10-F-21-HZ
APPLICATION FOR CERTIFICATE OF APPROPRIATENESS

1507 Forest Ave. 37916
Ft. Sanders NC

Original Print Date: 10/8/2021
 Knoxville/Knox County Planning -- Historic Zoning Commission

Level III Construction of New Primary Building

DUPLEX ① SIDE VIEW

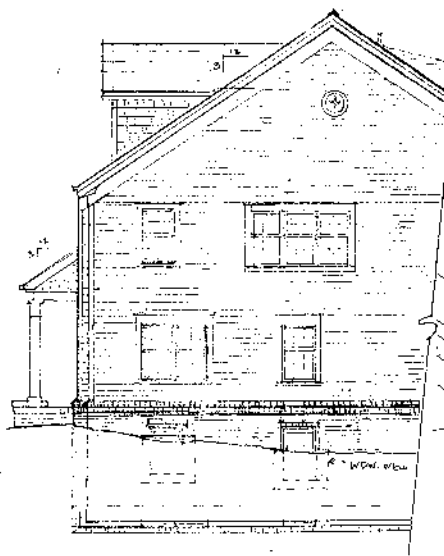
sufficient visual interest on the façade elevation. While the side elevations on Duplexes 1 and 2 are relatively flat, they have sufficient transparency and will be less visible from the right-of-way due to the placement of three houses.

7. The 1'-2' tall brick foundations are consistent with the historic context. The basement-level window wells in the foundation are unique features, but will be minimally visible from the right-of-way due to the construction of three adjacent houses and the proposed landscaping and trees.

DUPLEX ③ SIDE STREET VIEW

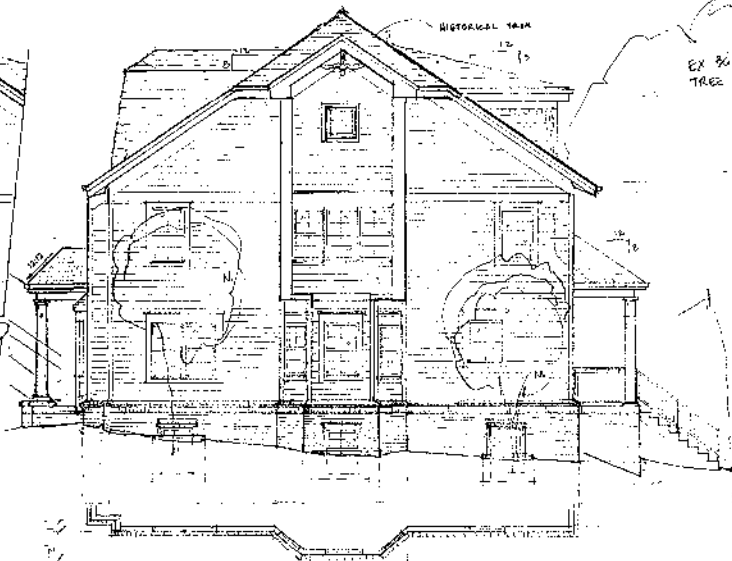
13. On Duplex 3, the side elevation will be significantly visible from James Agee Street. The incorporation of a projecting bay and canted bay contributes sufficient depth and visual interest for a corner house. The horizontal trim band on the projecting bay should be the same width as the trim band on the rest of the side elevation.

REAR
ELEVATION

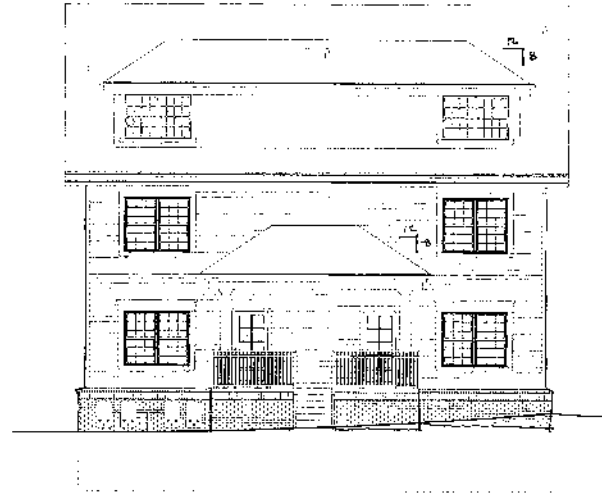
14. Due to the topography of the block, the location of parking lots (existing and proposed), and the height of the buildings, the rear elevations will be visible from the public right-of-way. In general, the rear elevations do not correspond with the facades. The dormer is disproportionately wide on the rear elevation, with windows placed at unusual distances. The rear elevation windows are different in size and detailing than front or side elevations, and the porch roofs do not reflect the porches on the facades. The rear elevations should be revised and submitted to the Commission for review.

- 1) Revision to rear elevations to correct proportions and more clearly correspond with facades, to be submitted to the Commission for review;
- 2) Updated site plan to reflect requirements of City Engineering and provisions of the zoning ordinance;
- 3) Material specifications to be provided to staff for approval, including correct eave overhangs, siding details,
